**PRELIMINARY/FINAL DRAINAGE REPORT  
FOR  
COPPER CHASE AT STERLING RANCH  
EL PASO COUNTY, COLORADO**

**Engineering Review**

January 2019

DSD Project # **PUDSP-19-003**

**FIRM PANEL W/ REVISED LOMR**

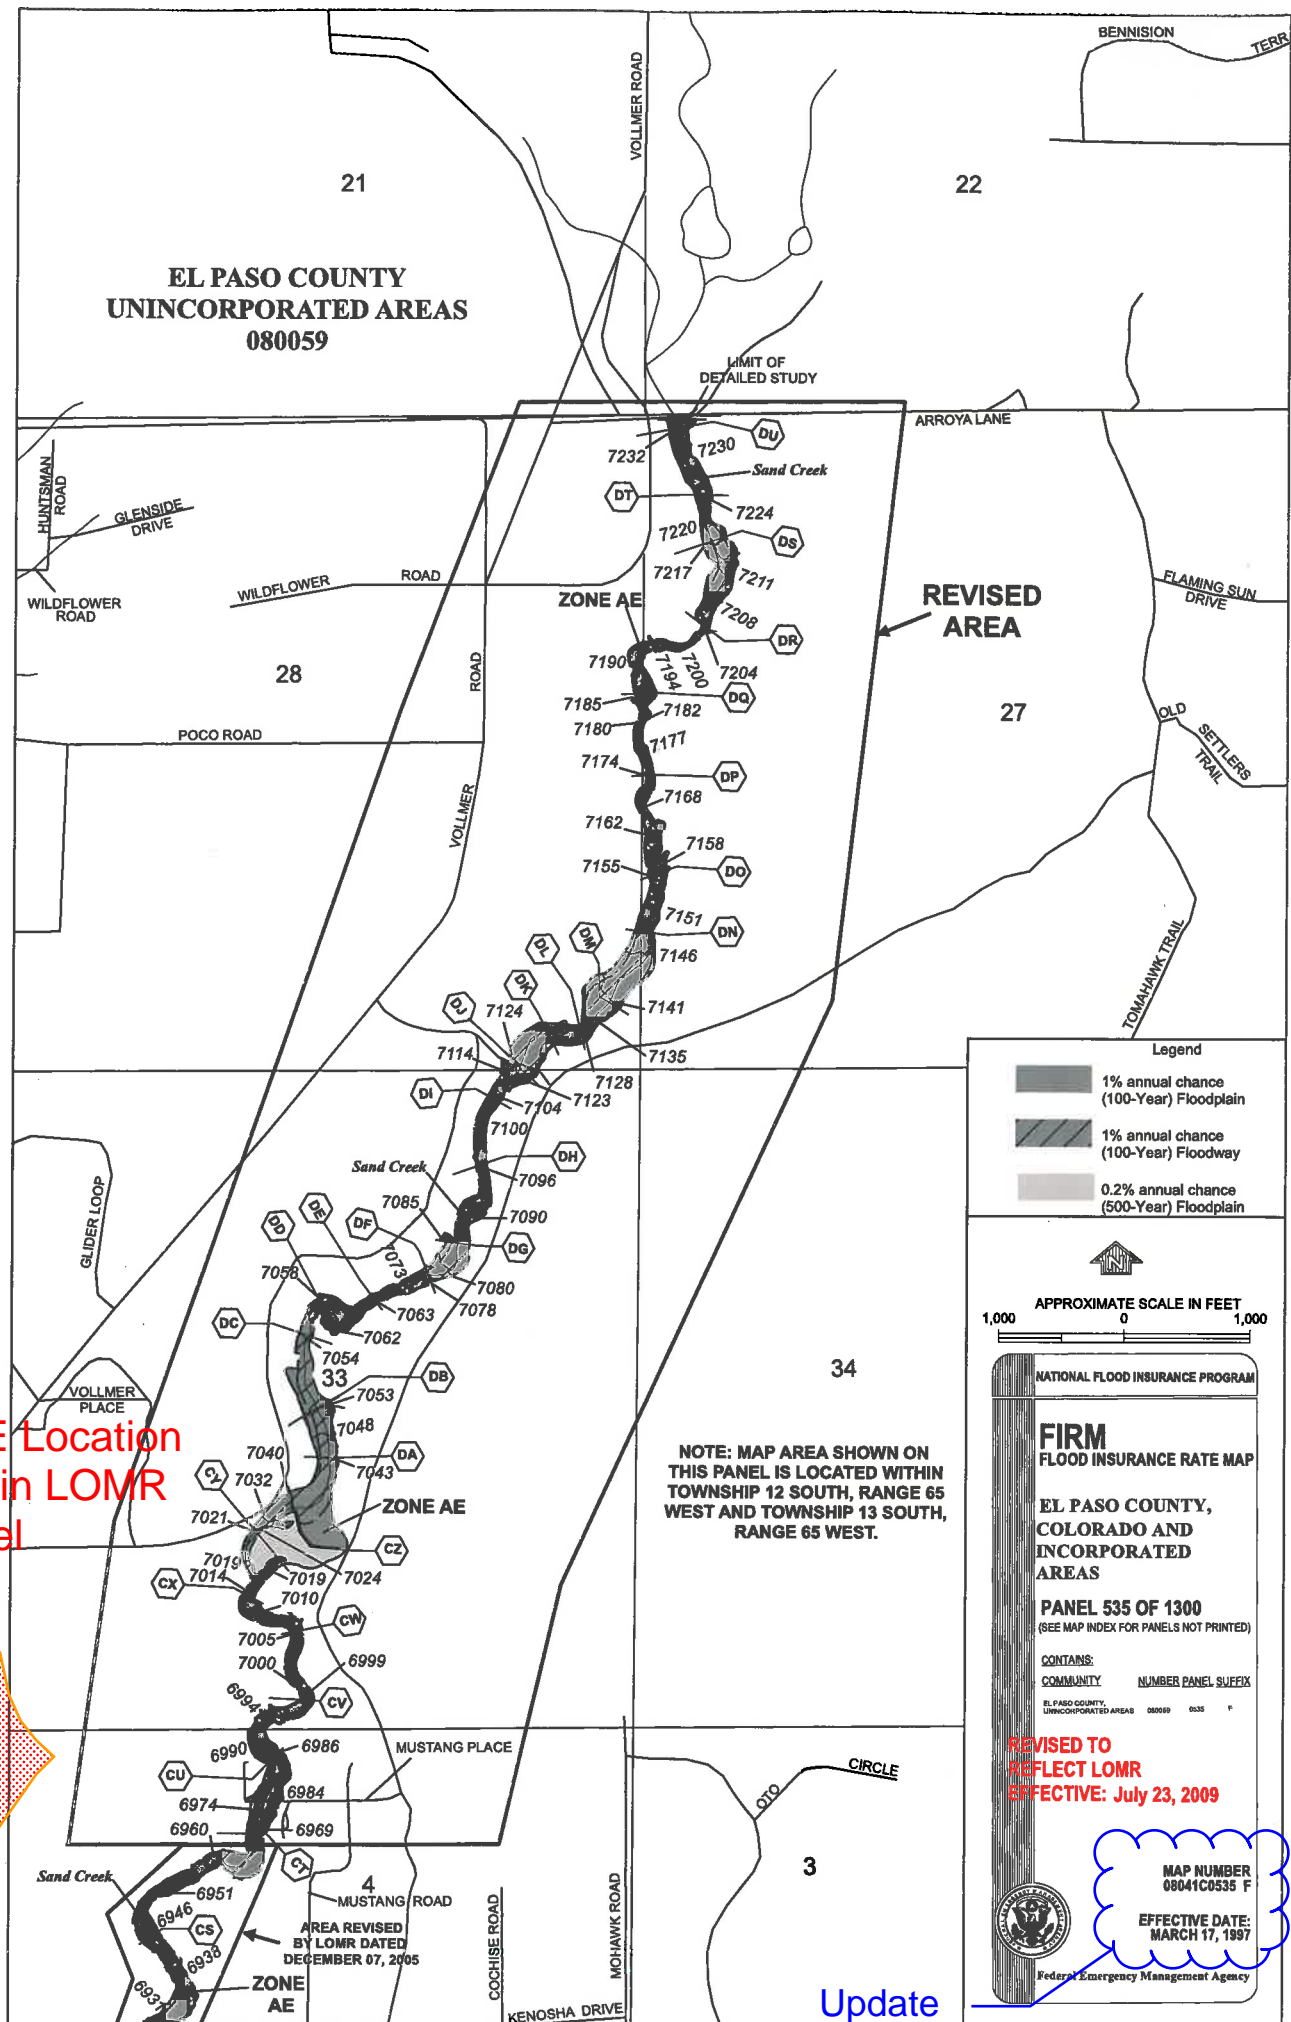
Update

### PROPOSED DRAINAGE MAP

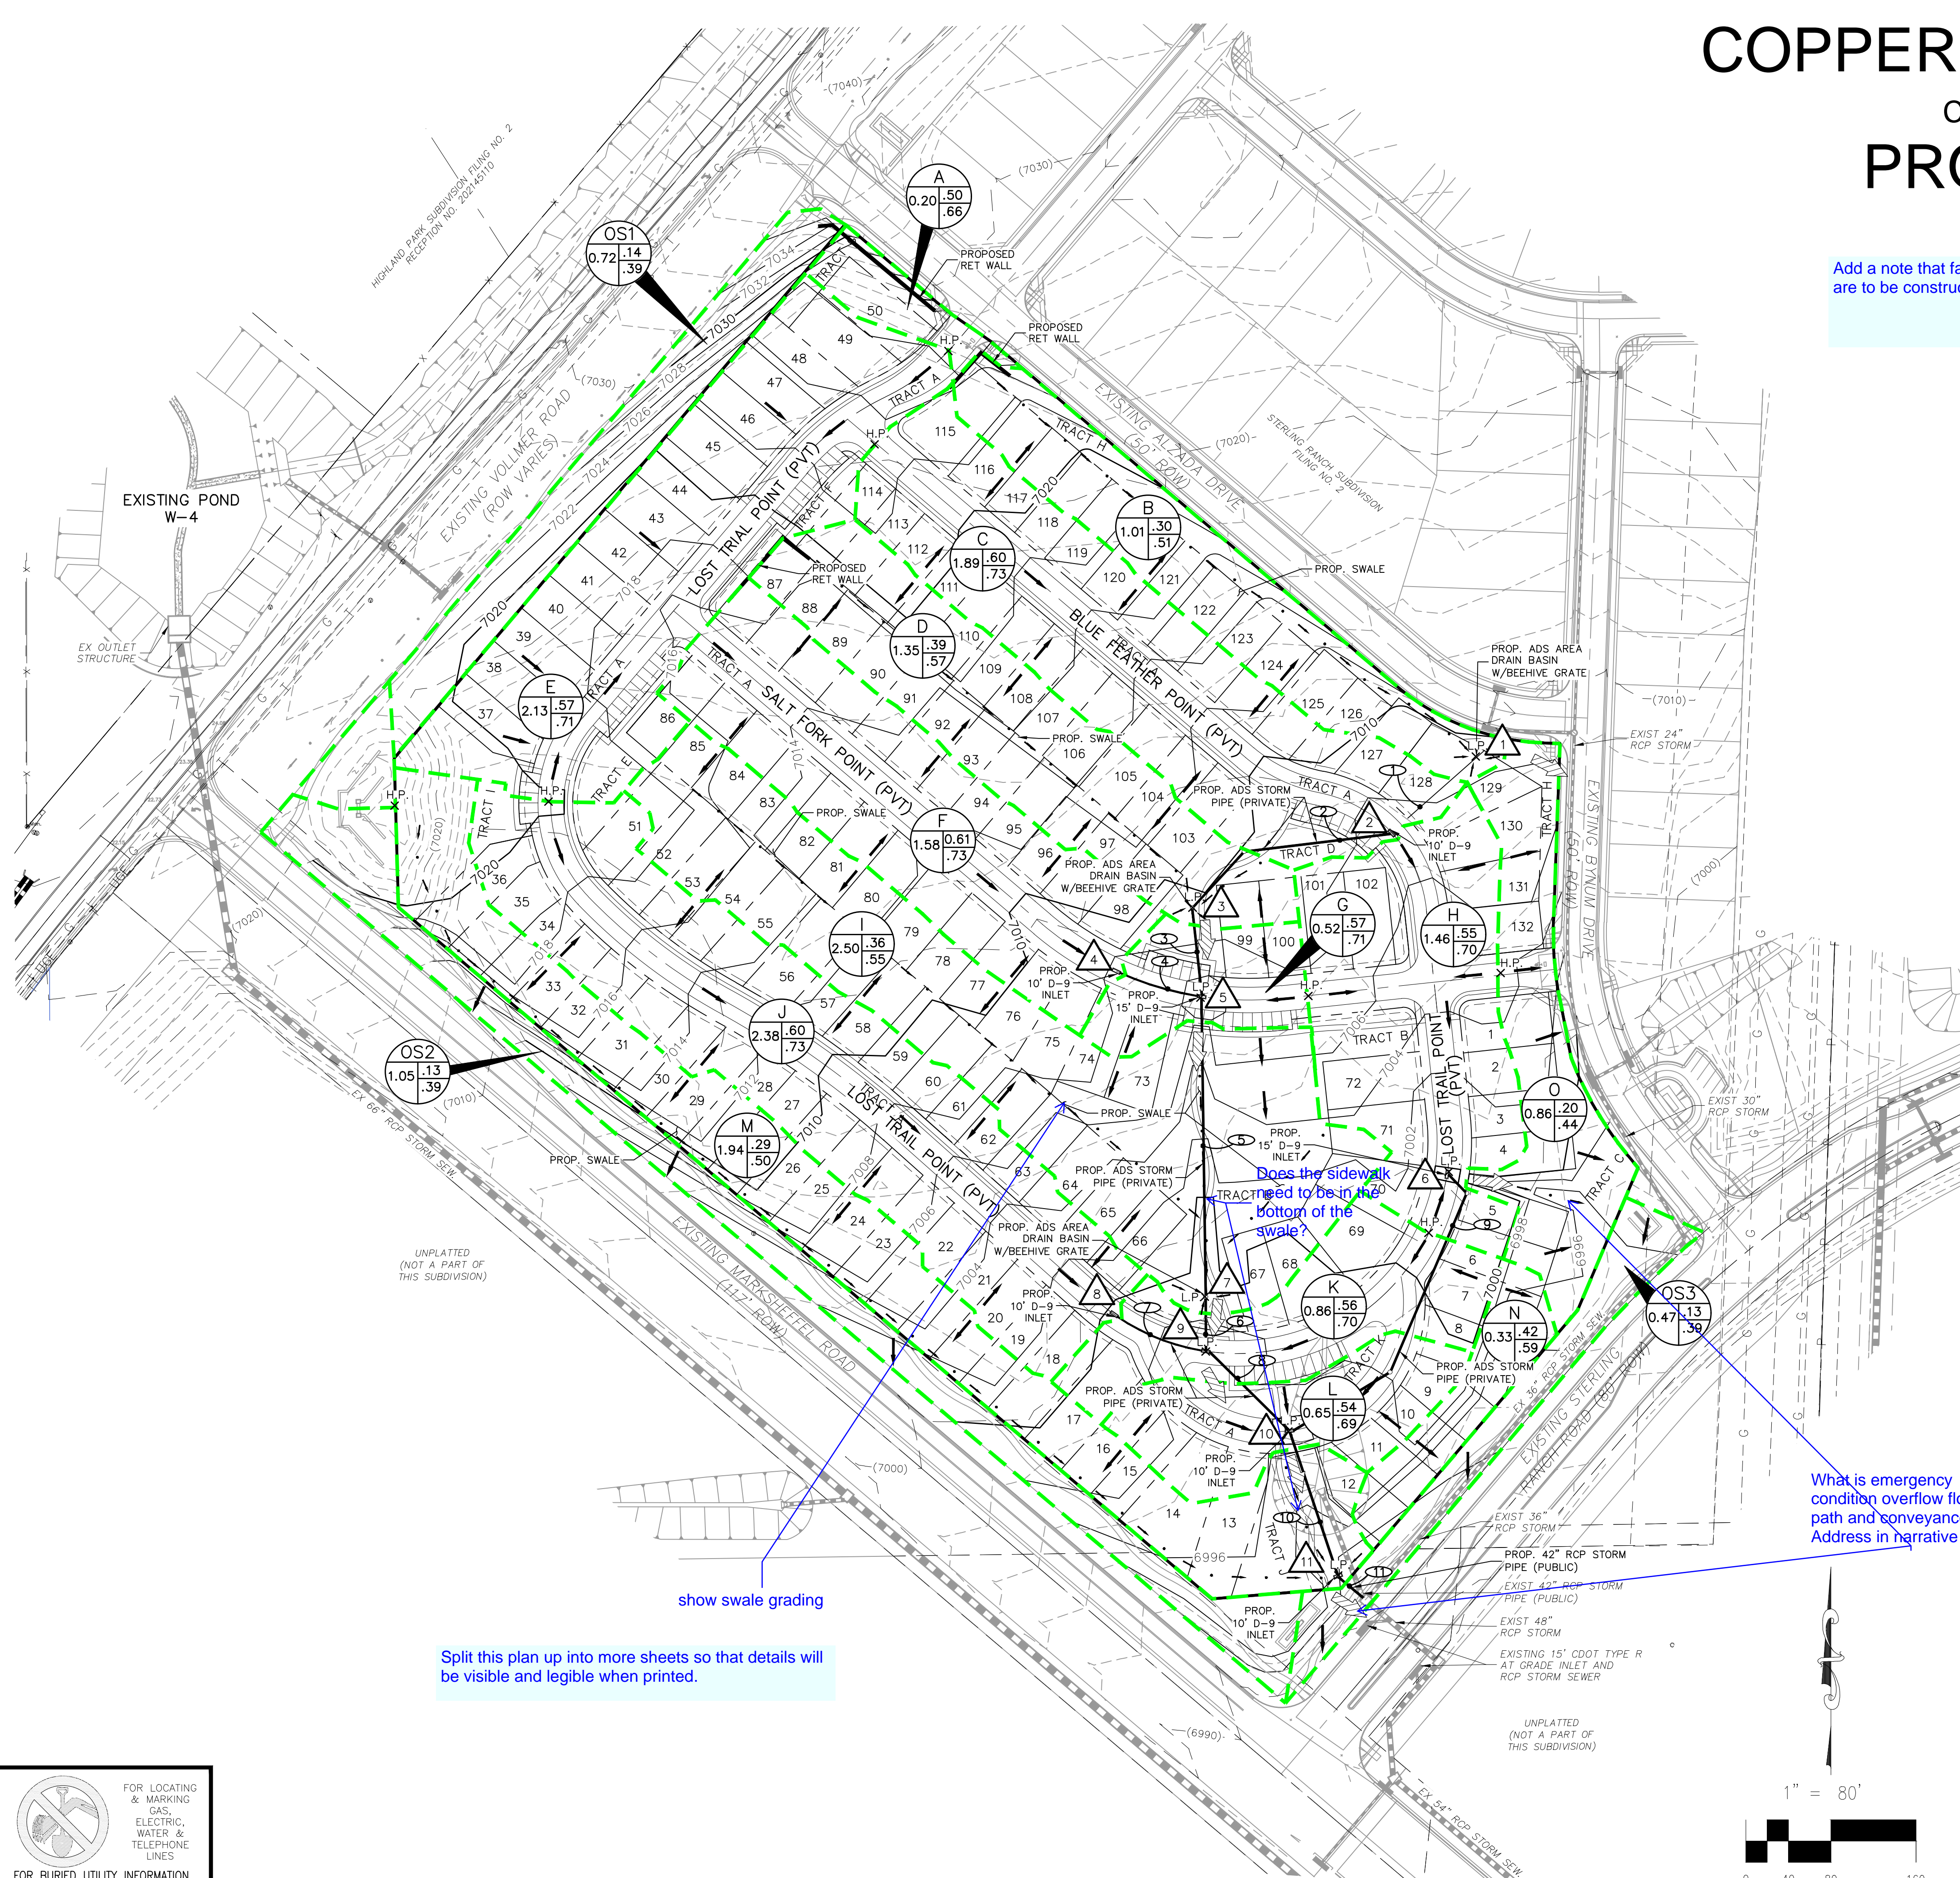
Add a note that facilities listed as existing are to be constructed with SR Filing #2.
